CRIME IMPACT STATEMENT

29-41 Maclure Road, Rochdale
38 No. Apartments & 4 No. Ground Floor
Commercial Units

VERSION A: 18th December 2023

REFERENCE: 2006/1349/CIS/01

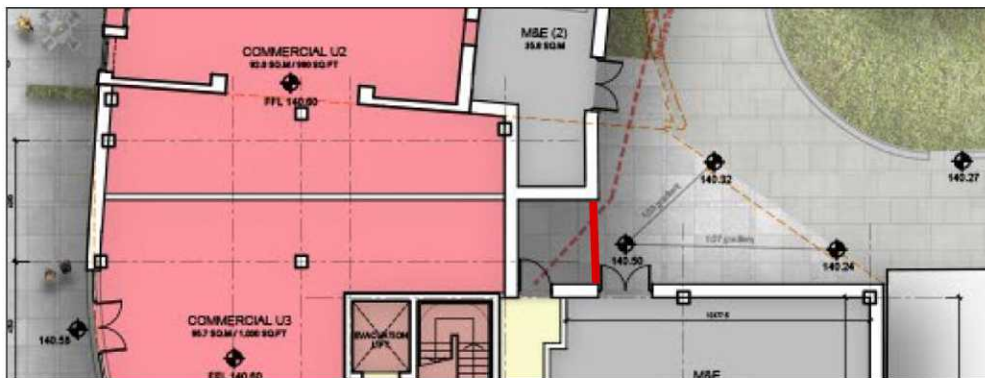
- 3.3.1 The main entrance into the apartment building, bin store, and cycle store, are recessed which can be problematic in town centre areas. Buildings with similar recessed buildings often experience misuse of these spaces, with loitering, drink/drug consumption, vagrancy, and public urination. If the recess must be retained, then it should be illuminated to a very high standard and covered by CCTV.

- 3.3.2 The rear entrance to the building is recessed and potentially concealed from view, depending on approach. It is highly recommended that the building line is altered (see above) so that it cannot be misused by criminals or antisocial individuals.
